Addendum No. 1

Project Name: N5012(1)1,2&4 Road Improvement Project in Sanostee, NM

Owner: Navajo Division of Transportation

4. Sheets 2, 3, 5, 8, 11, 17, 18, 19, 38, 39, 40, 61A, 61B, 65 and 66 of the N5012(1) plans have been revised. Revisions included changing the class of riprap from "Class 2" to "Class 1" and adding in the subgrade stabilization notes from the Pre-Proposal Meeting Agenda.

REGION	STATE	RESERVATION	ROUTE	PROJECT NO.	SHEET	TOTAL SHEETS
NORTH	NEW MEXICO	NAVAJO	N5012	N5012(1)1,2&4	61A	75

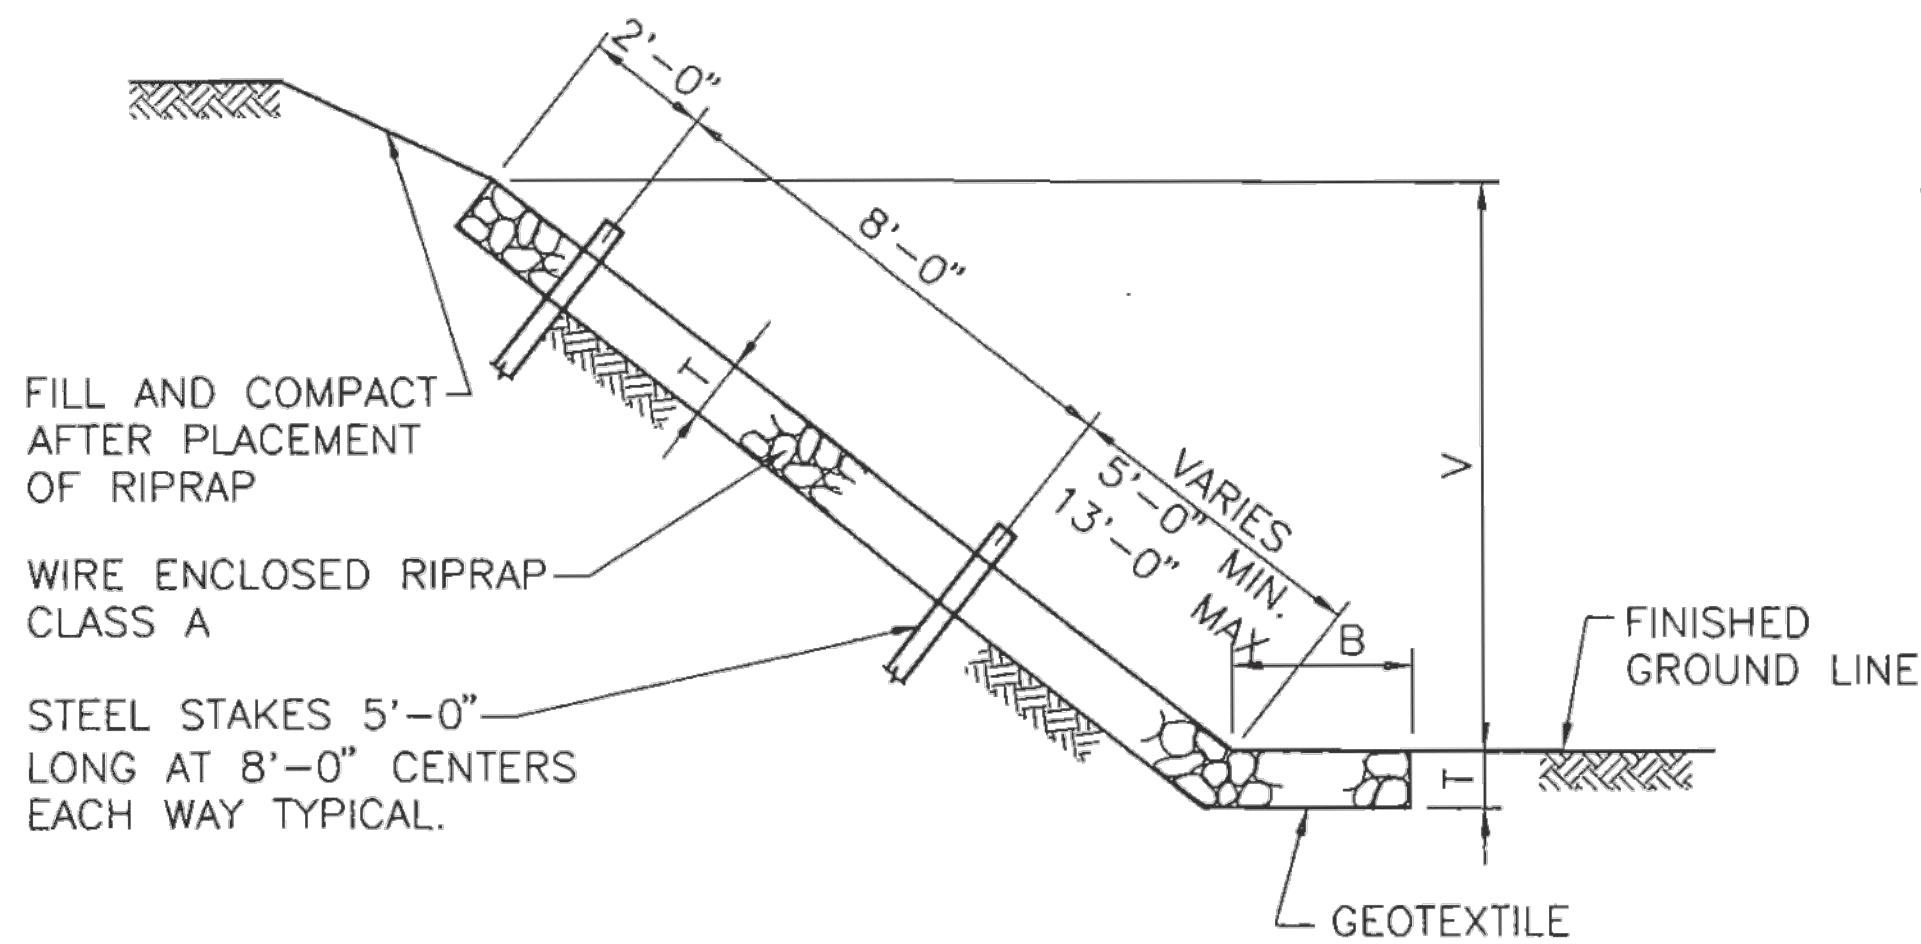
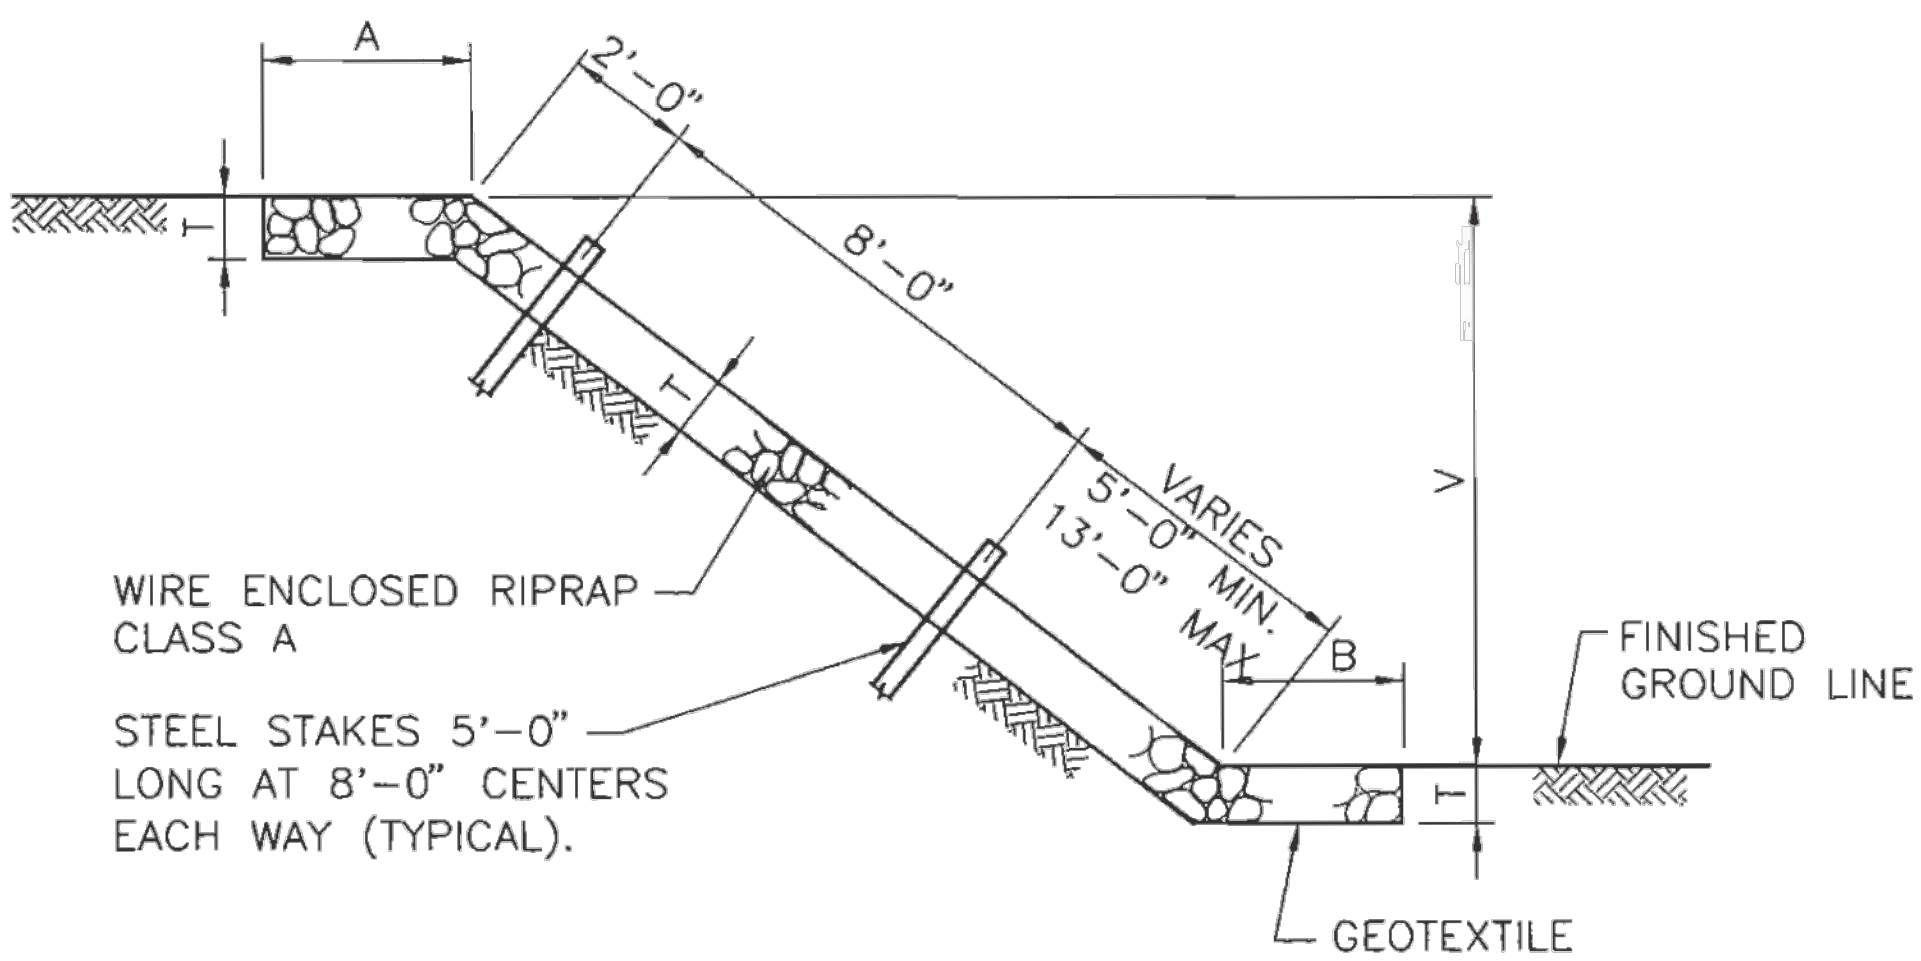
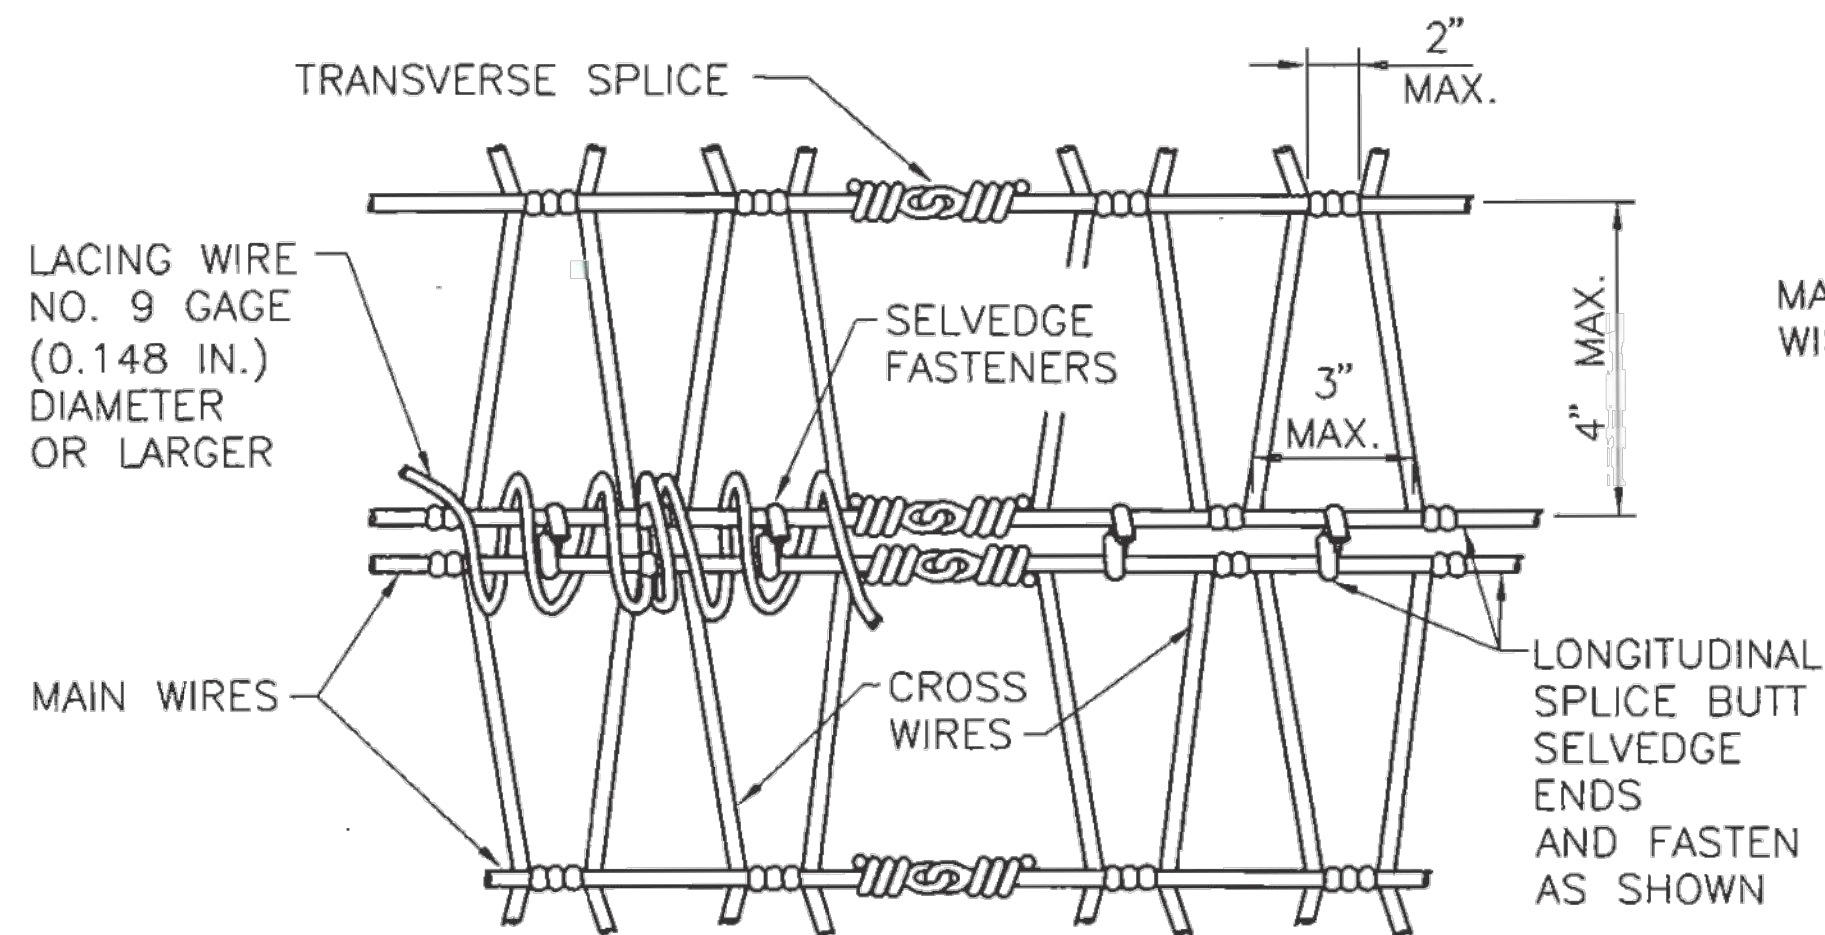
NOTE: REFERENCES WITHIN THIS DETAIL TO CLASS "A" RIPRAP IS EQUIVALENT TO BID ITEM 25112-2000 WIRE-ENCLOSED RIPRAP, CLASS 1

REVISED per ADDENDUM No. 1

REGION	STATE	RESERVATION	ROUTE	PROJECT NO.	SHEET	TOTAL SHEETS
NORTH	NEW MEXICO	NAVAJO	N5012	N5012(1)1,2&4	61B	75

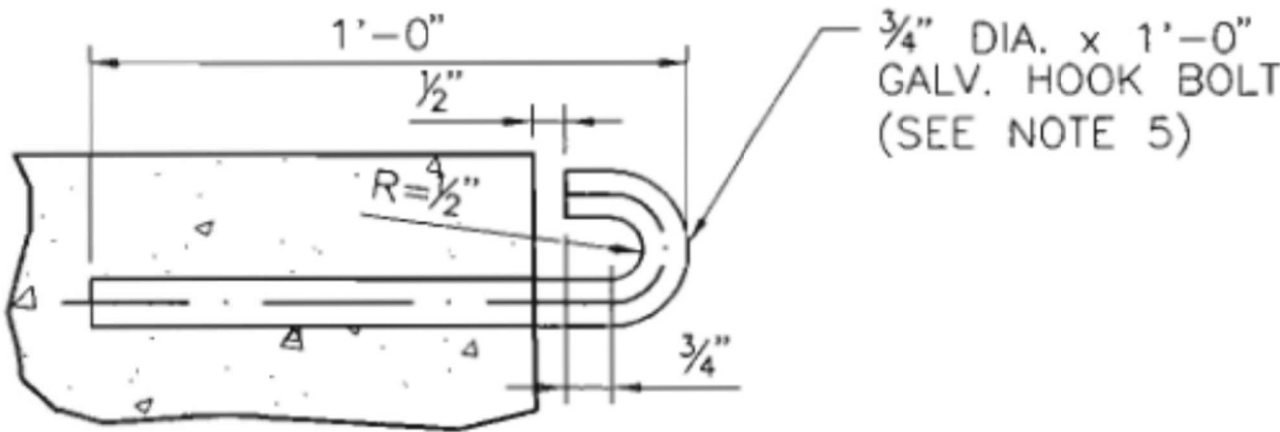
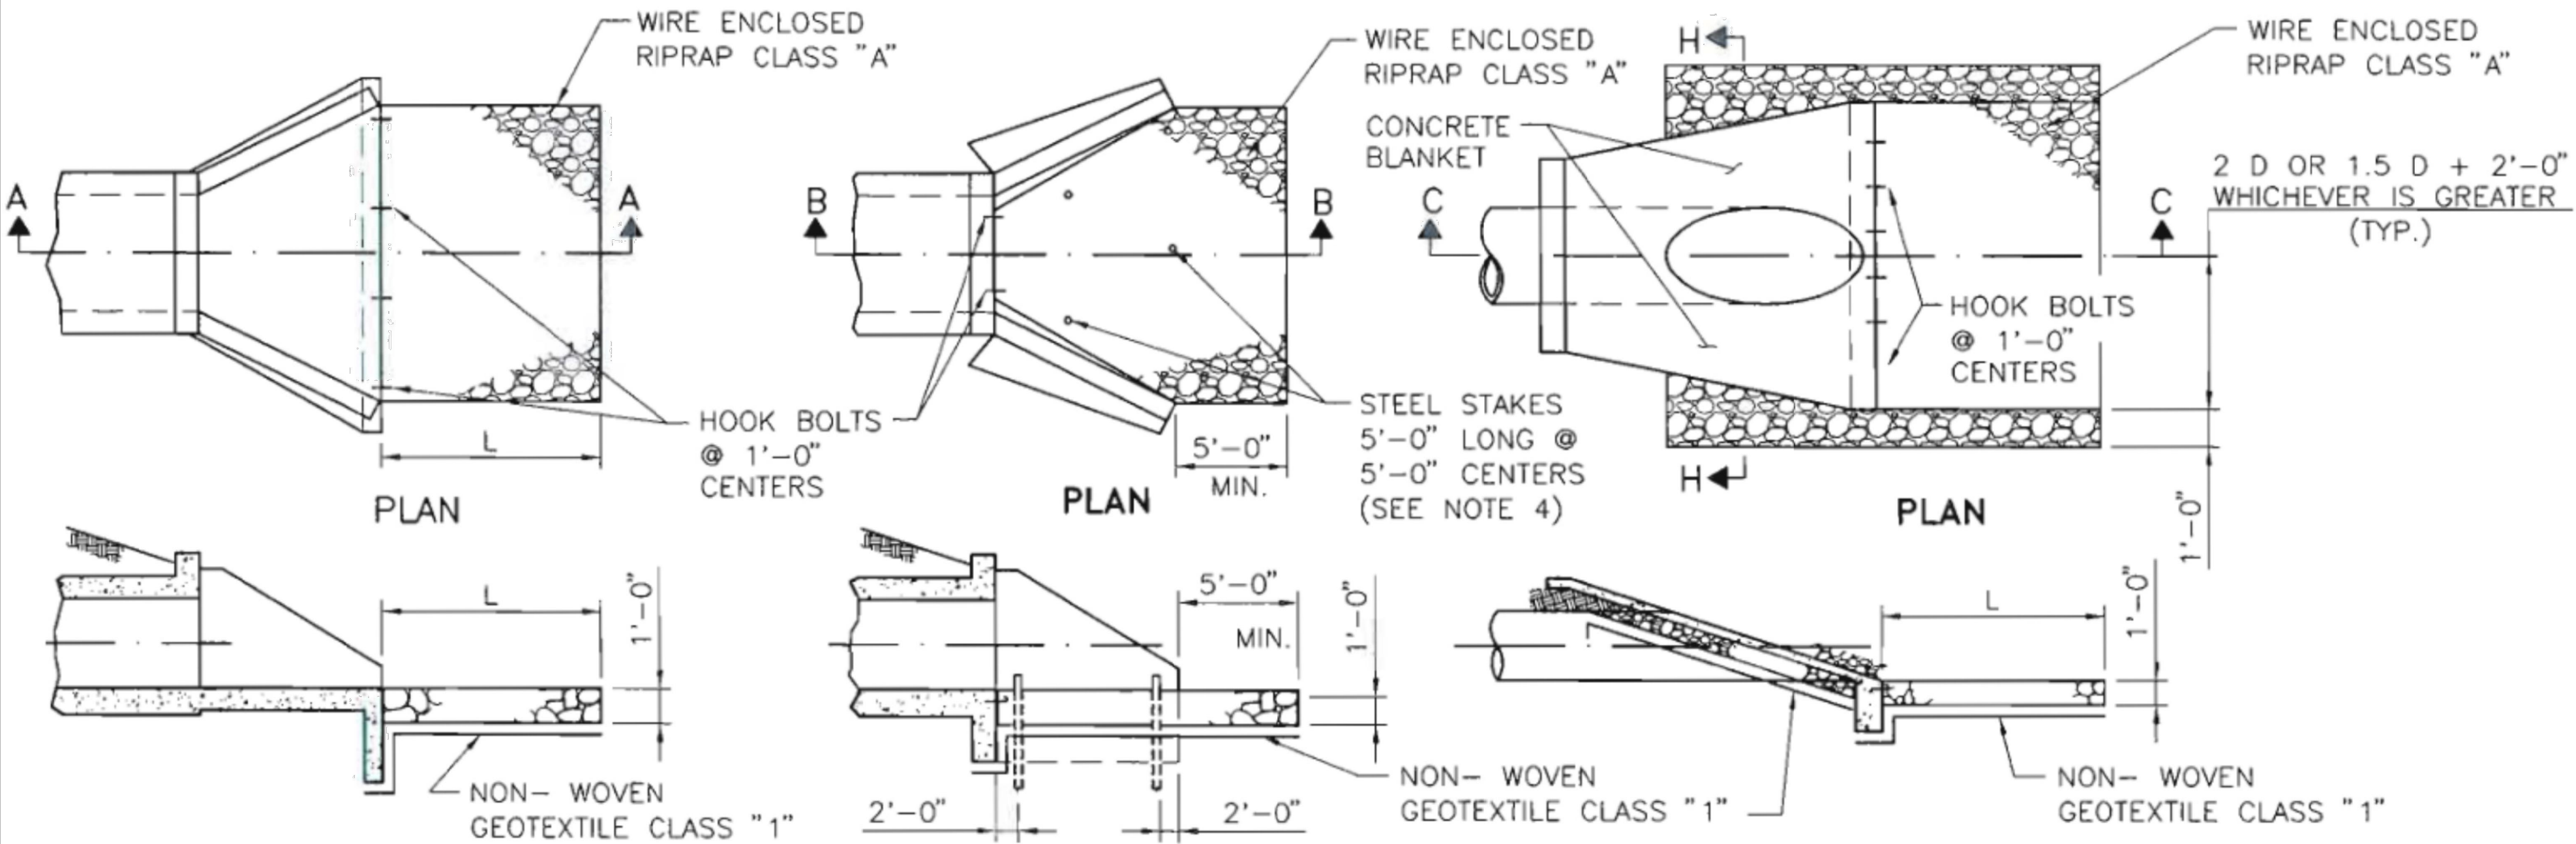
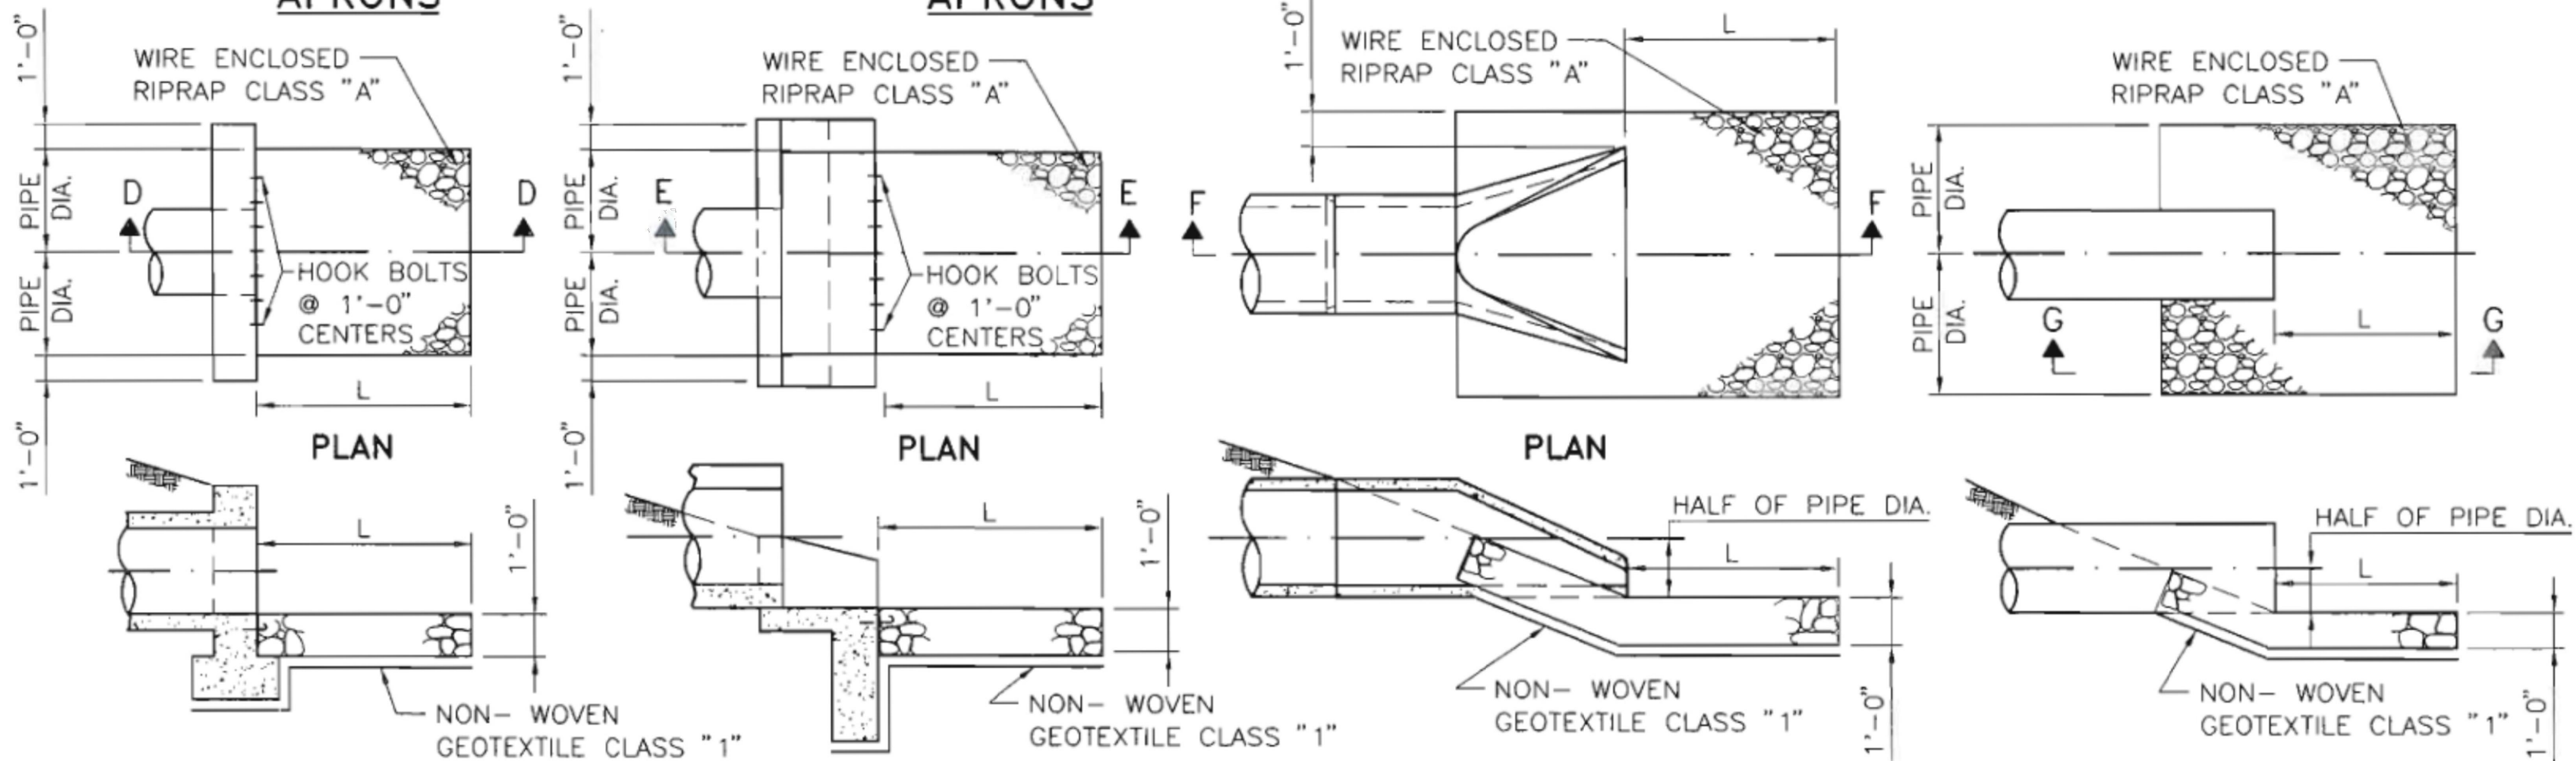
NOTE: REFERENCES WITHIN THIS DETAIL TO CLASS "A" RIPRAP IS EQUIVALENT TO BID ITEM 25112-2000 WIRE-ENCLOSED RIPRAP, CLASS 1

REVISED per ADDENDUM No. 1

REGION	STATE	RESERVATION	ROUTE	PROJECT NO.	SHEET	TOTAL SHEETS
NORTH	NEW MEXICO	NAVAJO	N5012	N5012(1)1,2&4	65	75

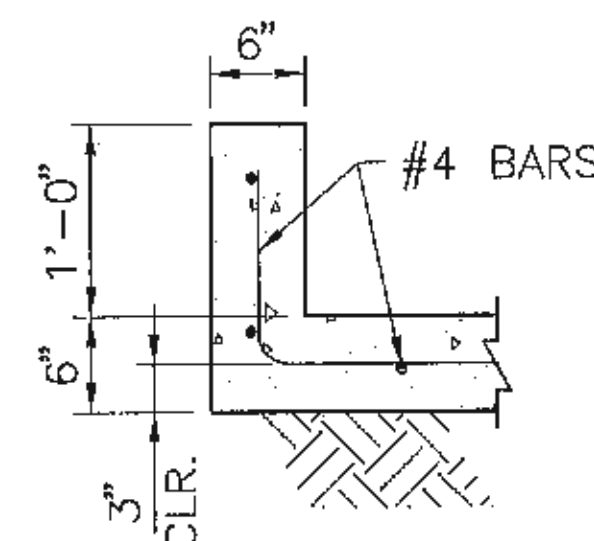
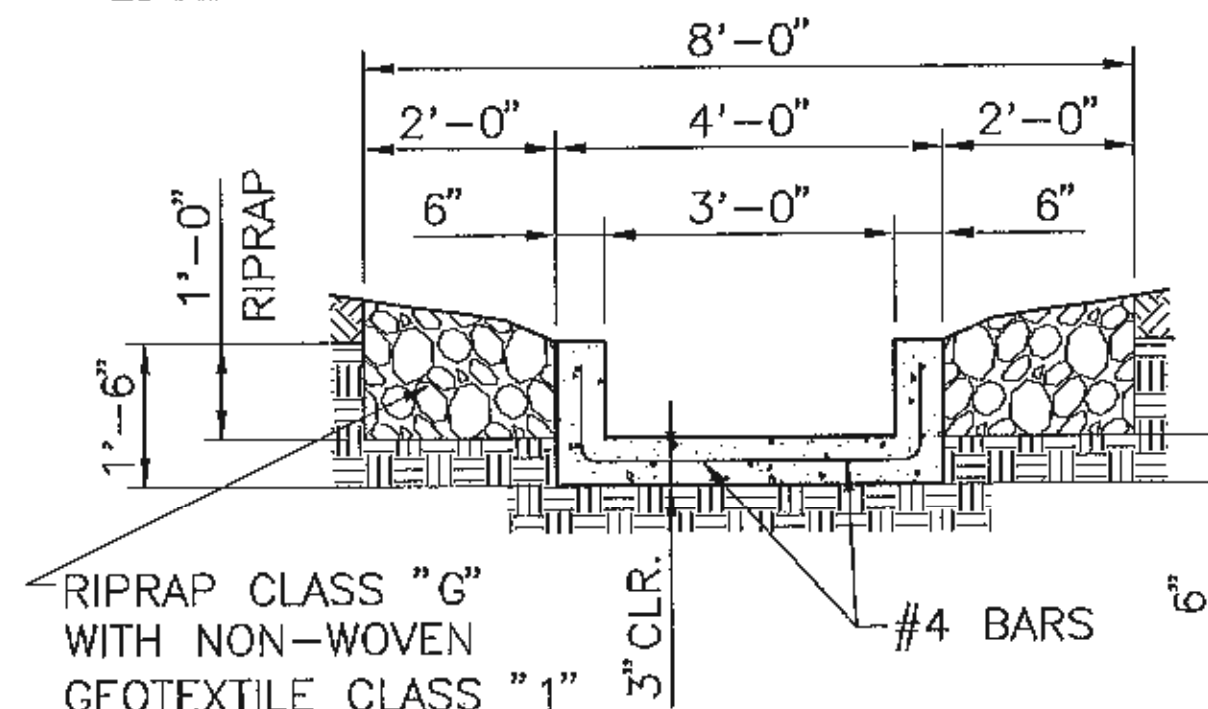
8. NOTE DELETED FROM PLANS

NOTE: REFERENCES WITHIN THIS SHEET TO CLASS "A" RIPRAP IS EQUIVALENT TO BID ITEM 25112-2000 WIRE-ENCLOSED RIPRAP, CLASS 1.

NOTE: REFERENCES WITHIN THIS SHEET TO CLASS "G" RIPRAP IS EQUIVALENT TO BID ITEM 25101-0100 PLACED RIPRAP, METHOD A, CLASS 1.
